15735 Camino Del Cerro – Peer Review #1 of the arborist report and recommendations for trees in the vicinity of the proposed development

15735 Camino Del Cerro – Peer Review #2, after review of project plan set

**Tree Inventory, Assessment,
And
Protection**

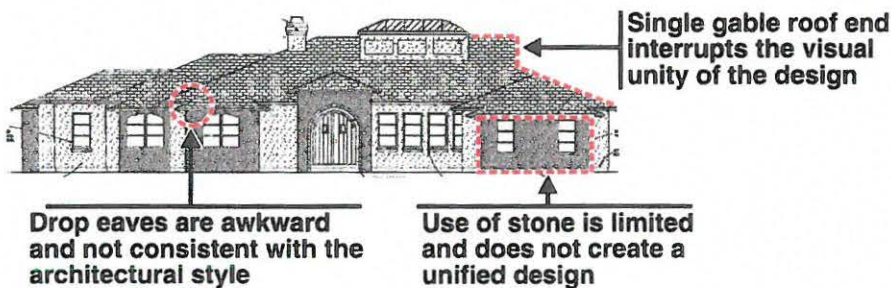
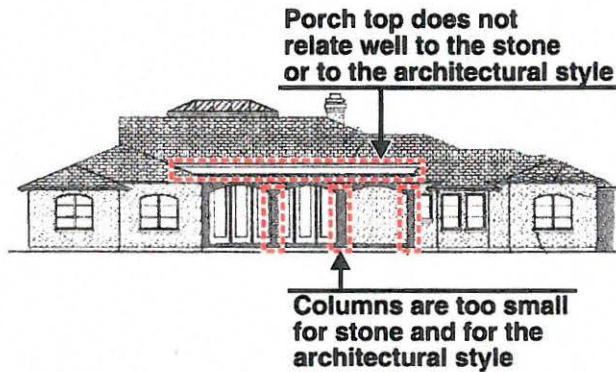
1. The architectural style is a bit eclectic, but seems to be drawing inspiration from the Tuscan and Mediterranean Styles. Stone veneer is employed in areas on three sides of the house (see diagram below), but it appears rather fragmented and used purely decoratively whereas the architectural style would usually include more stone relative to the stucco, and the stone would be used to define significant volumetric areas of the structure.

2. While hip roof forms are used extensively, there is one awkward area where a gable end is used to accommodate a large skylight over the Great Room.
3. The detail proposed for the drop eaves at bay pop outs is awkward, and not typical of the architectural style.

4. The columns at the rear covered patio are too small for the architectural style and for the scale of stone.
5. The parapet at the rear covered patio does not seem to work very well with the stone at the rear patio.

6. The depth of the wall area above the stone arch at the side of the rear patio is too small for a stone wall.

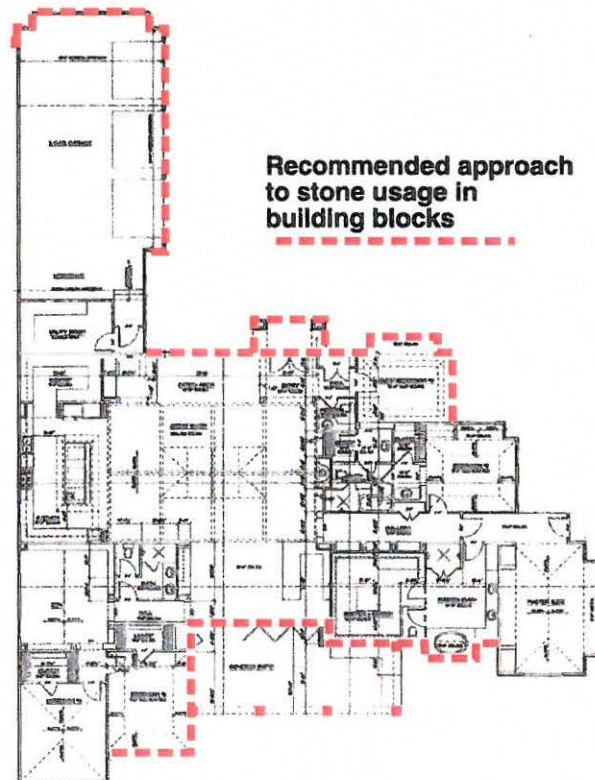
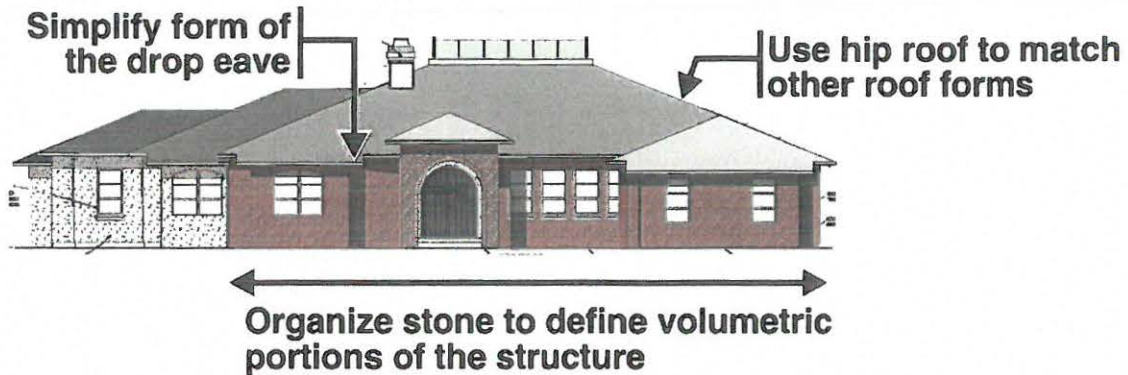
1. Increase the amount of stone facing, and consolidate the stone to define volumetric portions of the structure. There are undoubtedly a number of ways of doing this. One recommended approach is shown in the diagram to the right.

2. Replace the gable roof with a hip roof to match the remainder of the structure, and redesign the skylight to better integrate it with the roof form.

3. Design the drop eave in a more traditional manner.
